Cockle Bay Park development – Response to RMS Review of Amended Concept Proposal for DA SSD7684

We refer to the letter from Roads and Maritime Services (RMS) – RMS reference SYD16/00625/08 – dated 30 January 2018 which details RMS' response to the amended concept proposal for development application SSD7684. Within this letter, RMS identified items which will require consideration as part of the determination of the development application and resolution in the preparation of any Stage 2 development application. Responses to the following RMS identified items are set out below. The number reference relates to the item number in RMS' letter.

Figure 1: No central piers option

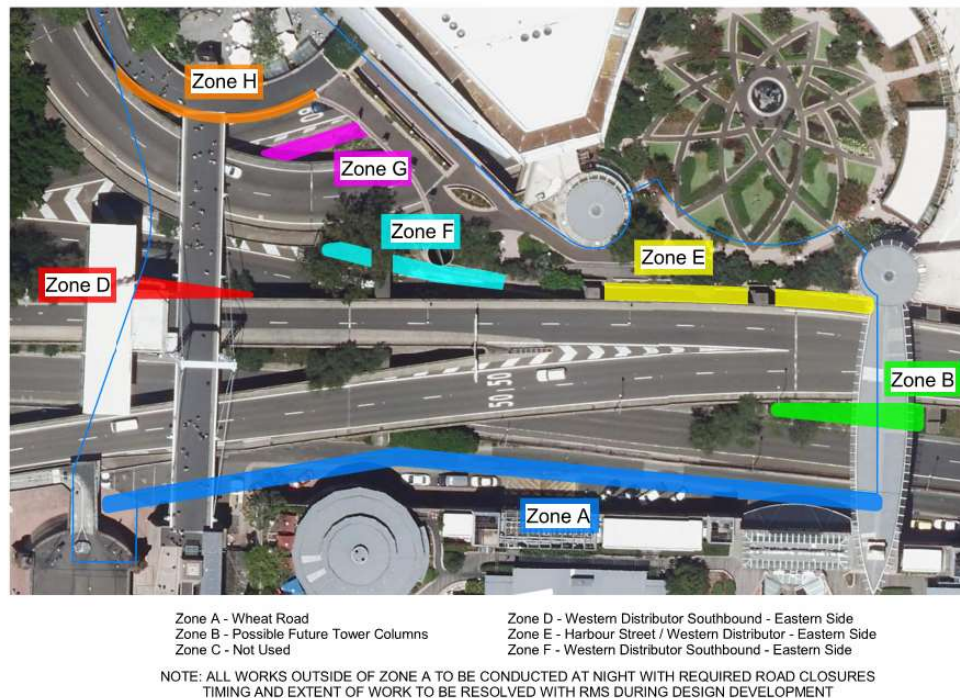
The design option previously presented to and agreed with RMS (refer to Figures 1 and 2 below) located all piers outside of the road corridor width. This includes piers located within zones G and H.

We trust that with the above clarifications, locating piers within zones G and H is conceptually acceptable for the purposes of design development in accordance with the previous coordination and conceptual agreement with RMS.

Figure 3: Allowance for future widening of Western Distributor between pier foundation zones G and H

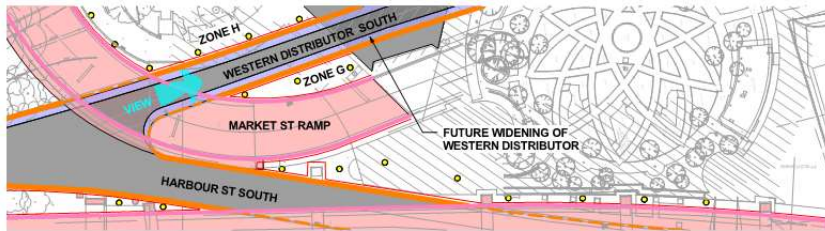
As requested by RMS, the pier locations in these regions also cater for a potential future widening of the Western Distributor to 2 lanes as shown in Figure 3 below extracted from Aurecon drawing 253427-002-SK-RD-0002-D which was included within Aurecon's Landbridge Design Principles report (dated 21 September 2017, Rev 2) under 'Appendix D Future RMS Projects and Structural Zones'. The available structural zones (indicated in blue) were coordinated with RMS to accommodate the existing road network as well as potential RMS projects for future road corridors.

Figure 5: Intent of clearance to elevated Western Distributor structure

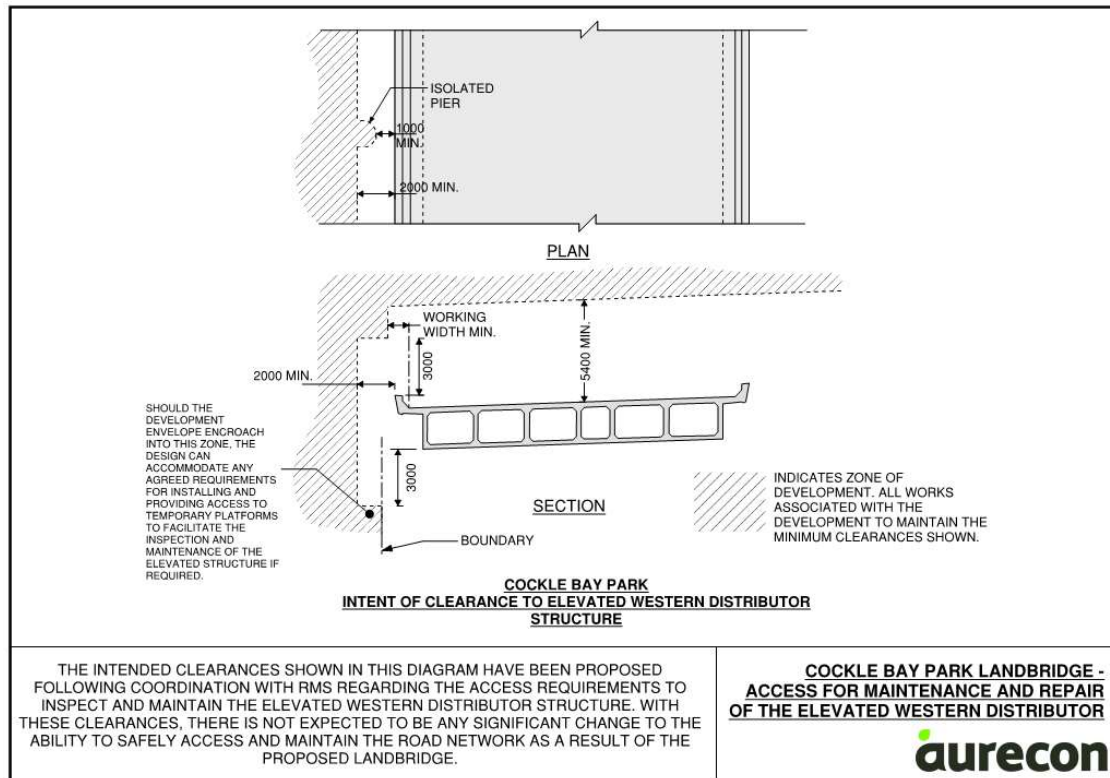
Notwithstanding the proposed condition of consent of a 3m exclusion zone noted in RMS' response to the revised concept, the approach discussed and verbally agreed with RMS in previous coordination was to allow construction to take place within 2m of the Western Distributor provided that it could be demonstrated that RMS are still able to effectively and safely maintain access for any repair and maintenance work that may be required. As such, the intent is for the development of the design to progress based on the proposed general clearance arrangement presented to, and discussed with, RMS during this previous coordination. The arrangement specified general clearance minimums as well as rules for isolated encroachments. The clearance arrangements were included within Aurecon's Landbridge Design Principles report (dated 21 September 2017, Rev 2) under 'Appendix E

Intent of Clearance to Elevated Western Distributor Structure' and have been reproduced below in Figure 5.

The development of the design through the stage 2 DA will enable the project team and RMS to coordinate and agree on the specific clearances to existing RMS infrastructure.
